Work Order ID 165766

Item Name: 206A/B/L-Series Cable Cutter System, High

APICAL INDUSTRIES, INC.	ENGINEERING CHANGE NOTICE NO. 03047				SHEET 1 OF 1	
	DWG NO. 646.9500	REV: NC	PREPARED BY J. JACKSON	DATE: 01/24/11	EFFECT ON DWG ☐ INC. ☒ UNINC.	
	DWG TITLE: 206 CABLE CUTTERS KIT					
	APPROVED BY: ENGR <i>[Signature]</i>	MFG <i>[Signature]</i>	QC <i>[Signature]</i>	EFF: NEXT ORDER		
TRANSACTION CODES (TC): A-ADD C-CREATE R-REVISE D-DELETE	REASON: ADDED GPS MOUNT KIT, F/N 52. REVISED DRAWING VIEWS. ADDED NOTE <u>2</u> .

206 CABLE CUTTERS KIT

SHEET 1, ZONE B1 IS:

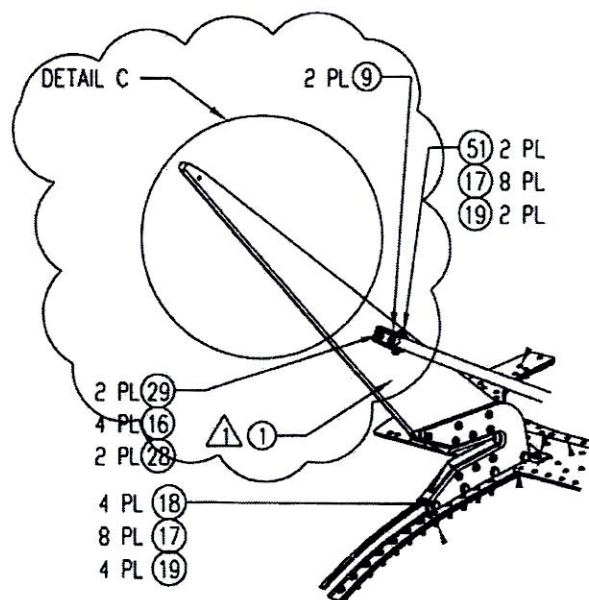
2 AT CUSTOMERS OPTION, INSTALL F/N 52 BY MATCH DRILLING ONTO F/N 1.

SHEET 2, ZONE B2 IS:

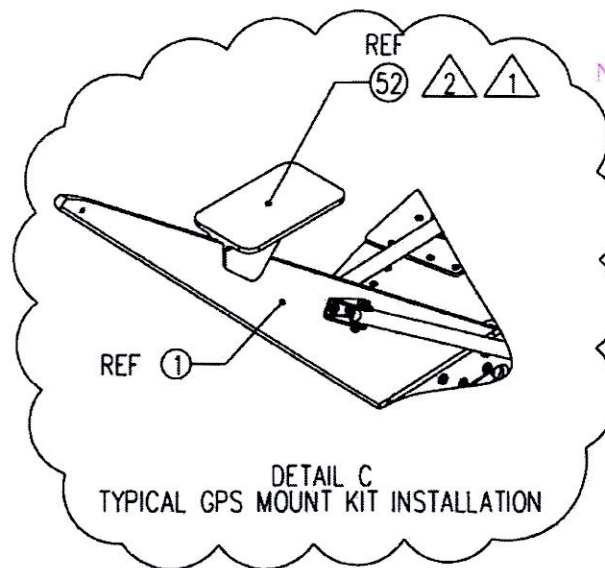
SHEET 2, ZONE A3 IS:

SHEET 2, VIEW IS:

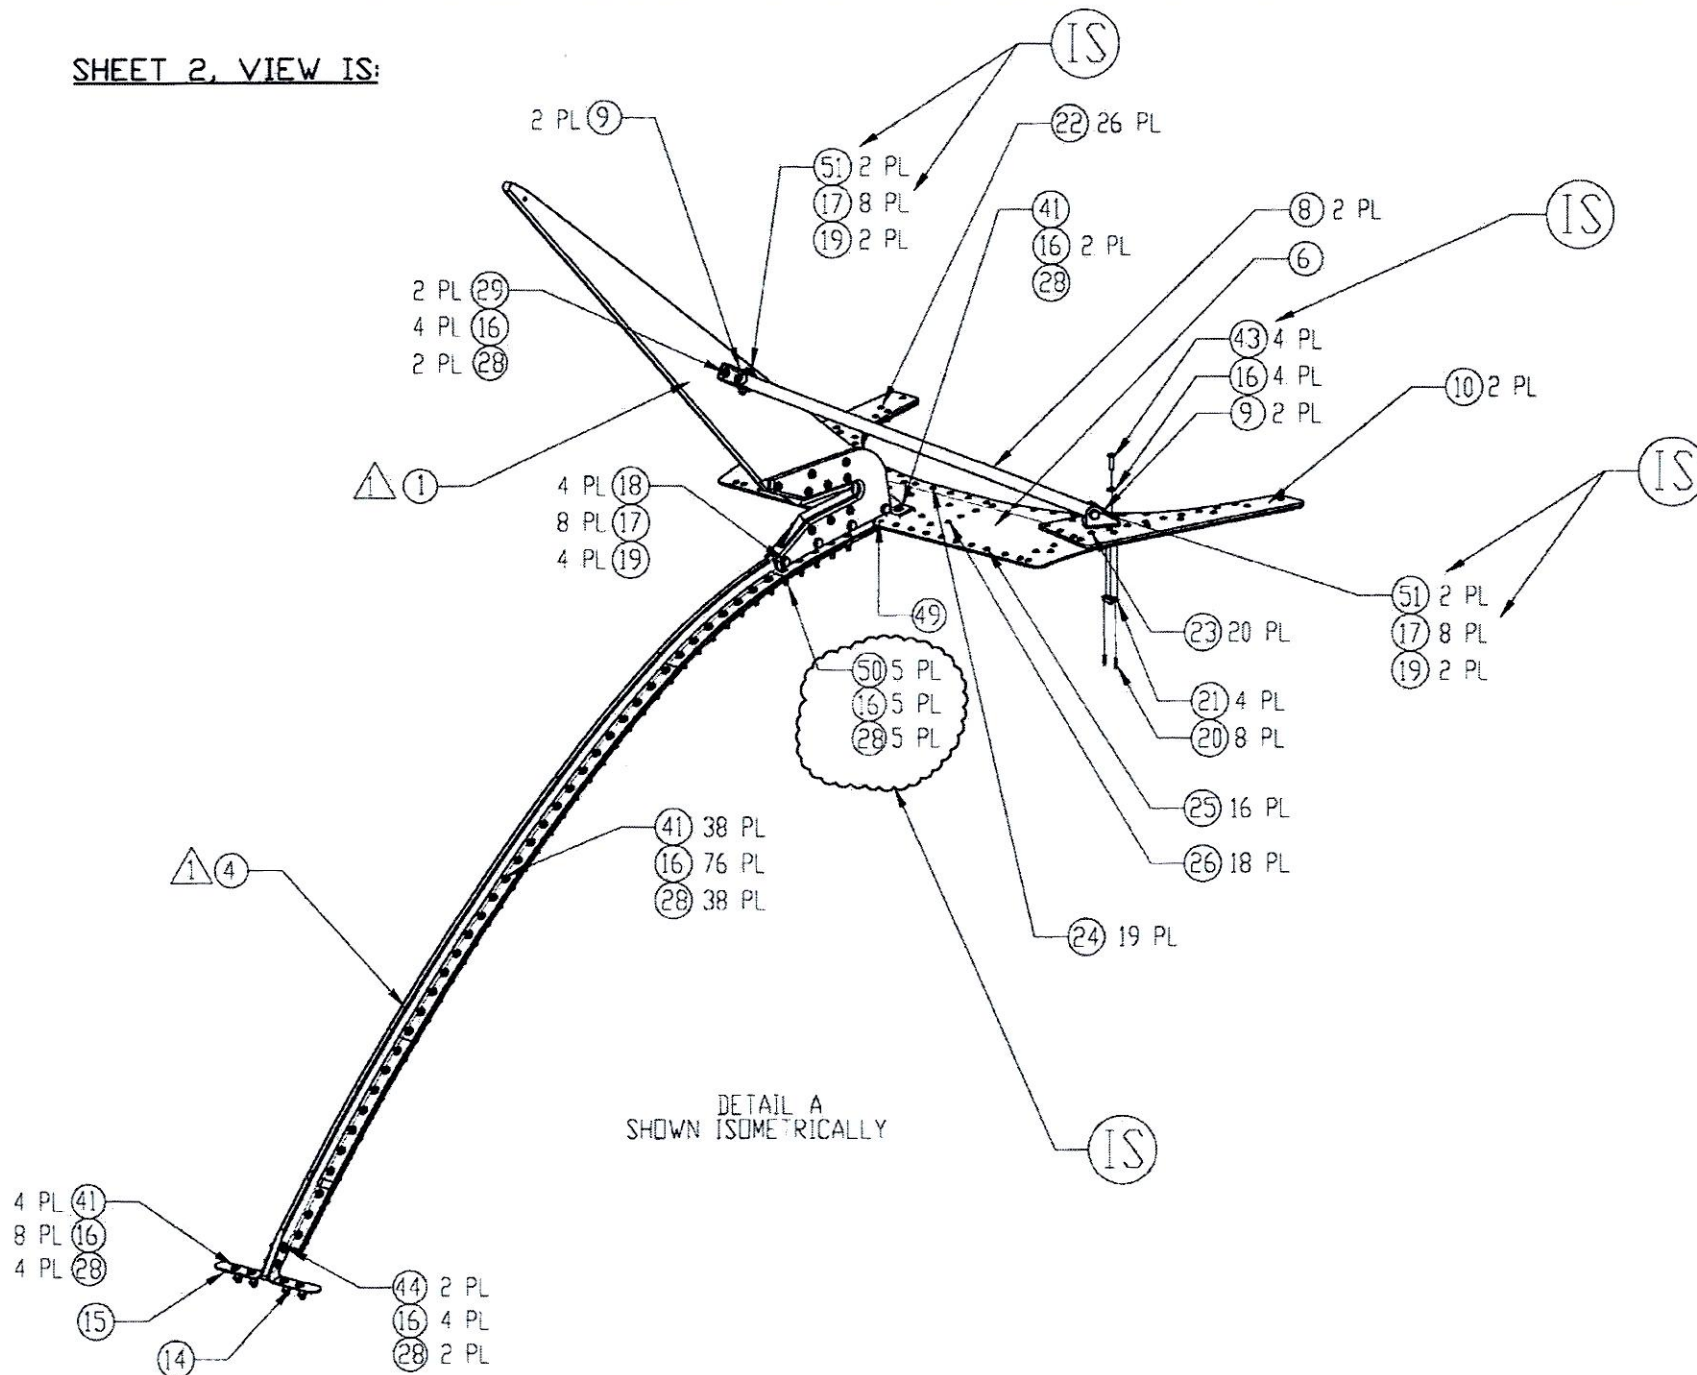
APICAL INDUSTRIES, INC.	ENGINEERING CHANGE NOTICE NO. 02729				SHEET 1 OF 3	
	DWG NO. 646.9500	REV: N/C	PREPARED BY S. HUFF	DATE: 12/23/09	EFFECT ON DWG ☐ INC. ☒ UNINC.	
	DWG TITLE: 206 CABLE CUTTERS KIT					
APPROVED BY:		ENGR <i>[Signature]</i>	MFG <i>[Signature]</i>	QC <i>[Signature]</i>	EFF: CURRENT ORDER	
TRANSACTION CODES (TC): A-ADD C-CREATE R-REVISE D-DELETE		REASON: HARDWARE REVISIONS FROM FIRST INSTALL

51	A	601.3155	8	8	BOLT	AN3-10A
50	A	601.3153	5	5	SCREW	MS24694S8
41	R	601.2893	43	43	SCREW	MS27039-0811
28	R	601.2973	54	54	LOCKNUT	MS21042-08
18	R	601.2826	8	8	BOLT	AN3-11A
16	R	601.2764	127	127	WASHER	NAS1149FN832P
			9502	9501		
F/N	TC	PART NUMBER	QTY		DESCRIPTION	MATERIAL/SPECIFICATION

SHEET 3, ZONE B2, IS:

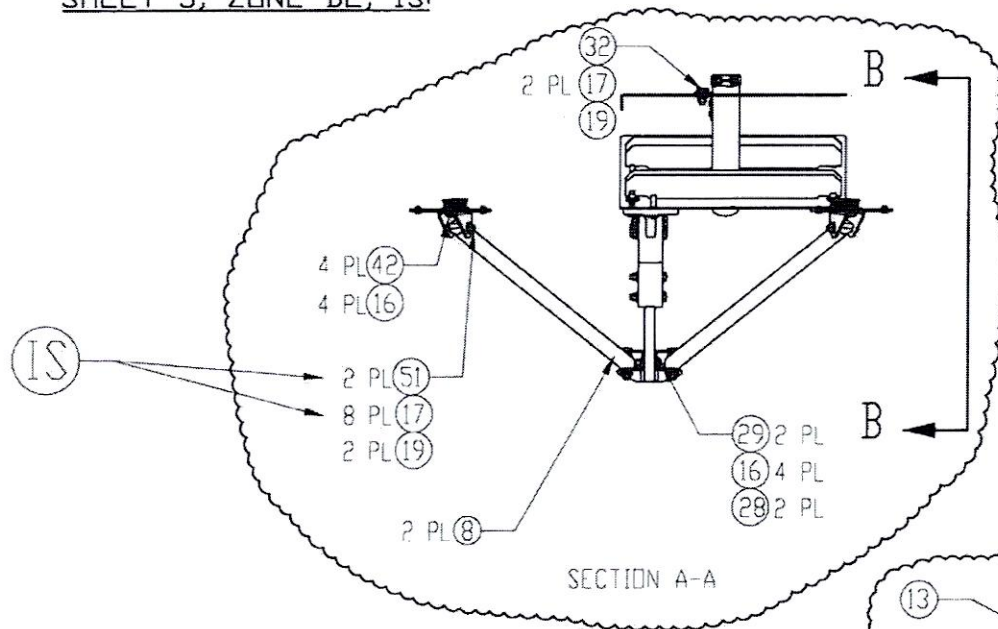
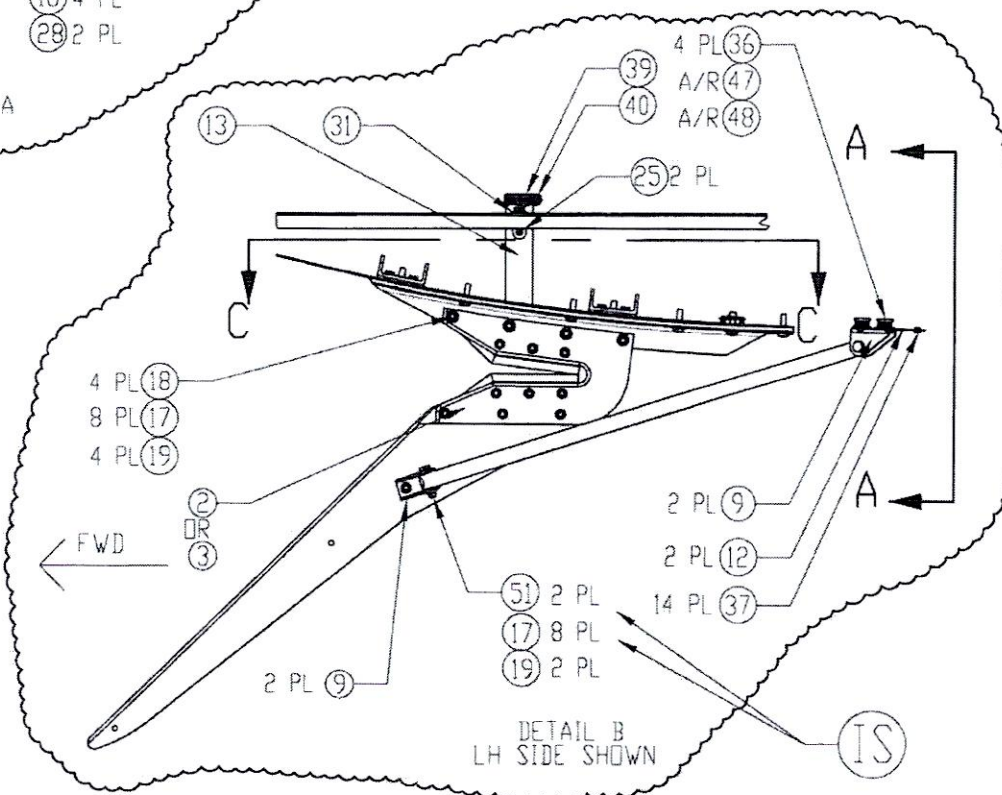
SHEET 3, ZONE D2, IS:
